Case Manager: Sobia Sayeda, Senior Planner

SITE PLAN DESCRIPTION: The applicant requests review and approval of a Site Plan for a new commercial building with a drive-through, associated parking and landscaping, and other traffic circulation elements at 1247 Trinity Drive on a property within the Downtown-Neighborhood Center Overlay (DT-NCO). The existing building and dumpster enclosure will be demolished to construct the new building.

SITE PLAN - EXHIBIT D

IDRC REVIEW: The Interdepartmental Review Committee (IDRC) independently reviewed the requests on May 13, 2021. Below are the responses received:

GRADING PLAN - EXHIBIT E

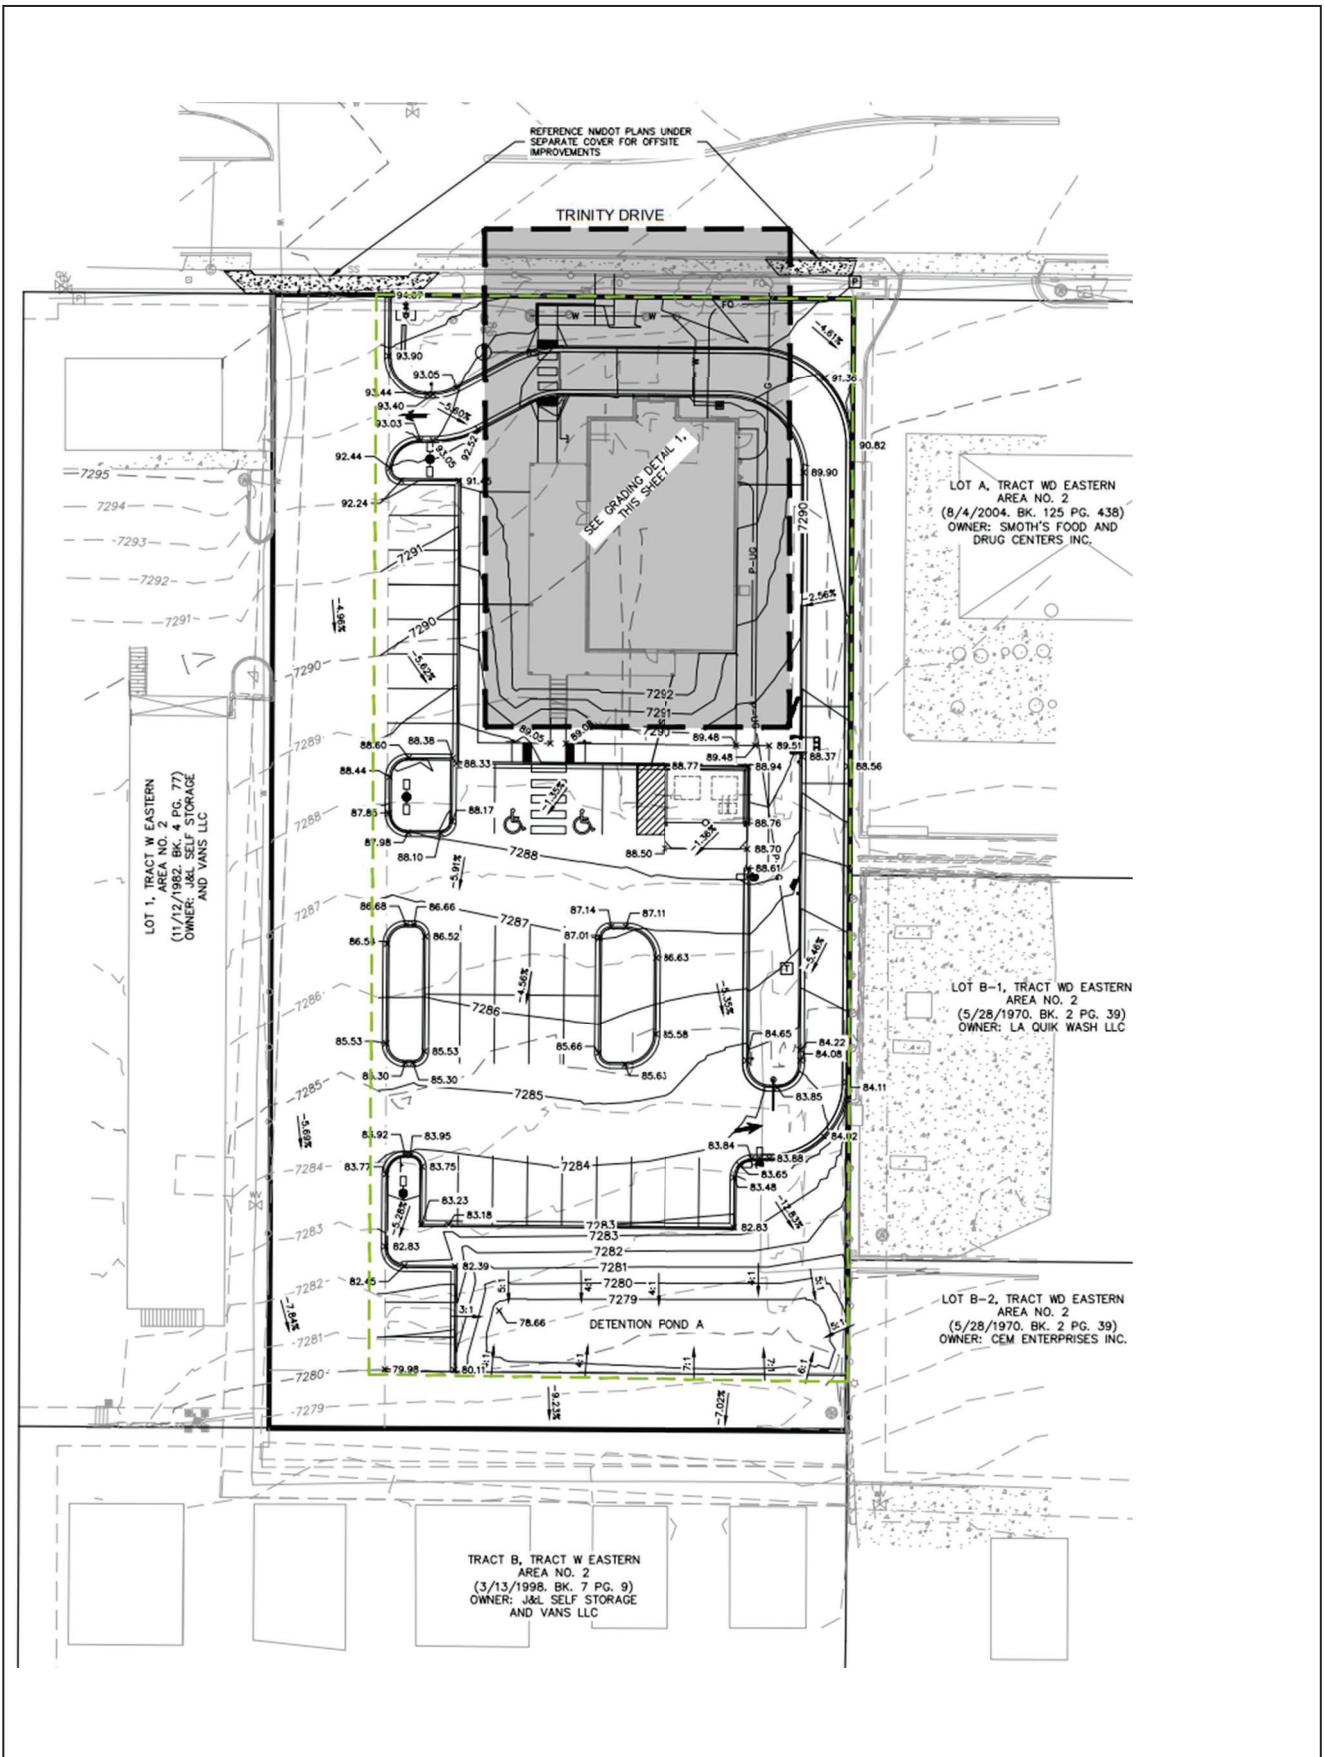
- 1) Sheet C4.0: The drainage analysis indicates analysis on Basis 1 and Basis 2, but the grading and drainage plans only shows Basin 1 delineated. Please provide additional details and delineation for Basis 2 on the plans when submitting your application for permit.
- 2) Please submit the Site Threshold Assessment (STH) along with NMDOT approvals for County review as soon as possible. The Site Plan Application indicates that the STH was submitted, but it was not found in the documents.

SITE PLAN

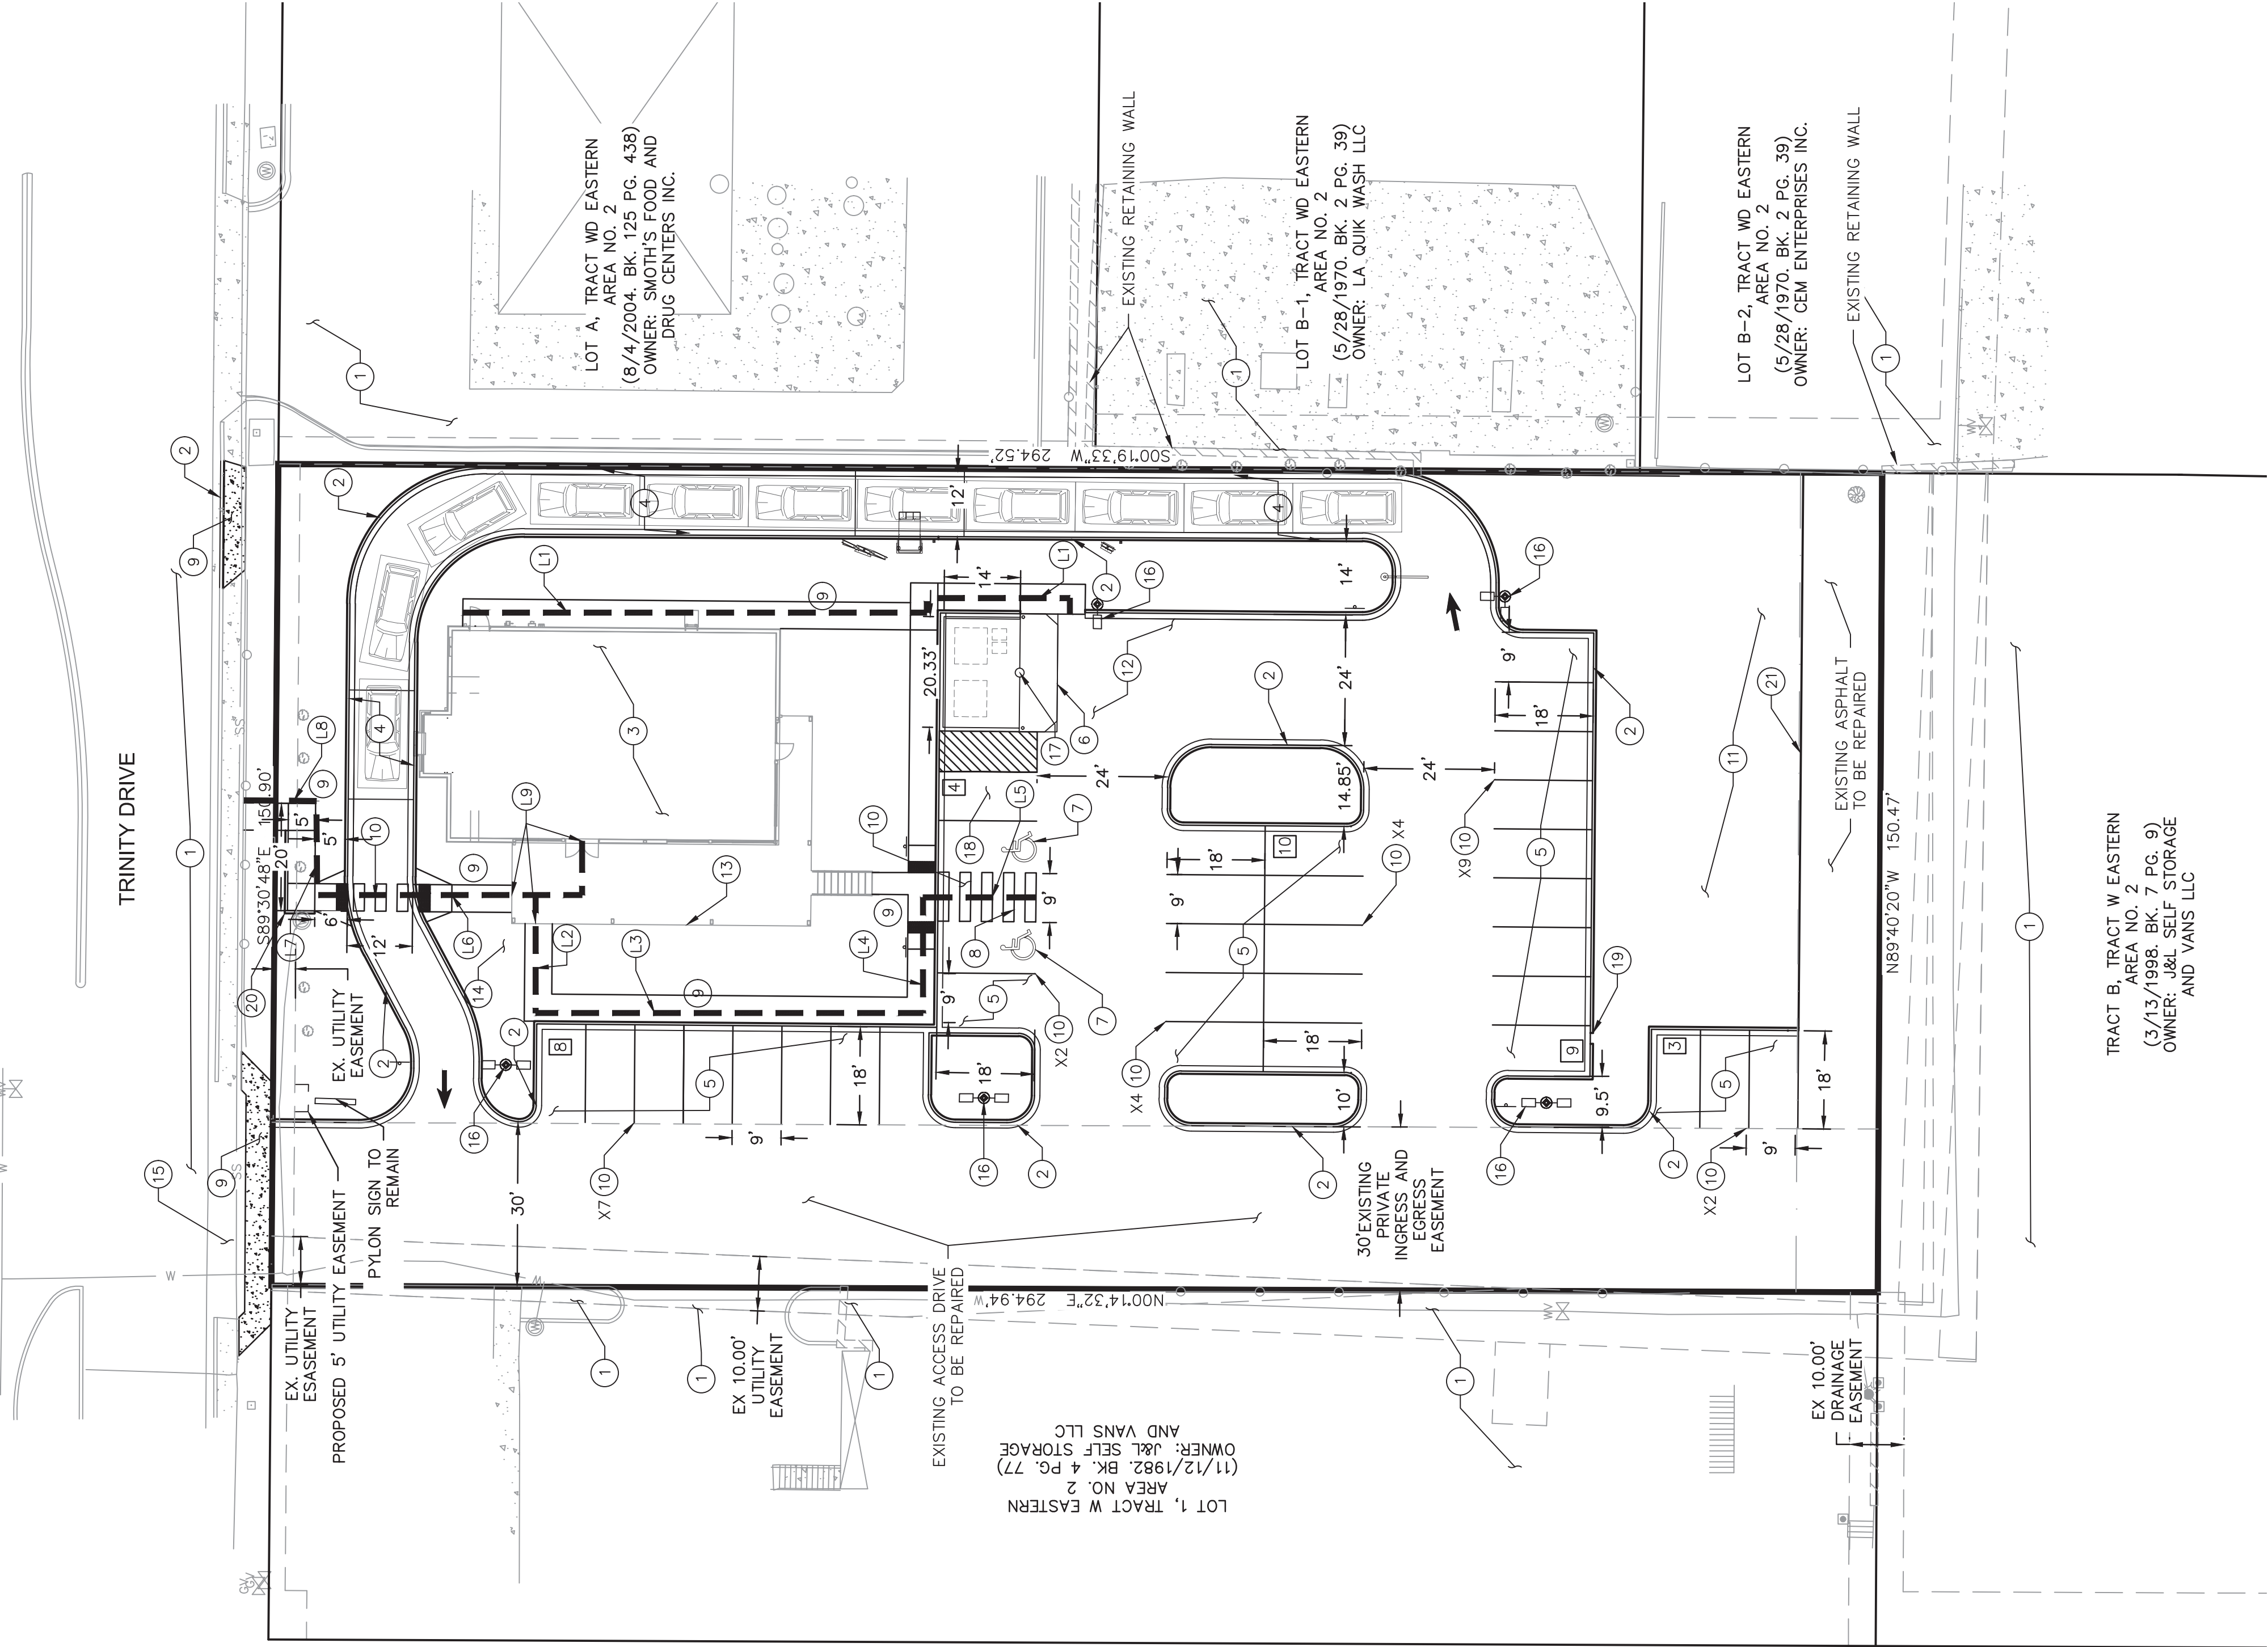
- 1) Identify means to address exit discharge egress emergency illumination for the (main) exit doorway onto the exterior landing under the porch covering.
- 2) Identify proposed location of hydrant on plan (hydrant moved from Trinity) - new location not indicated or clear on plan as drawn.
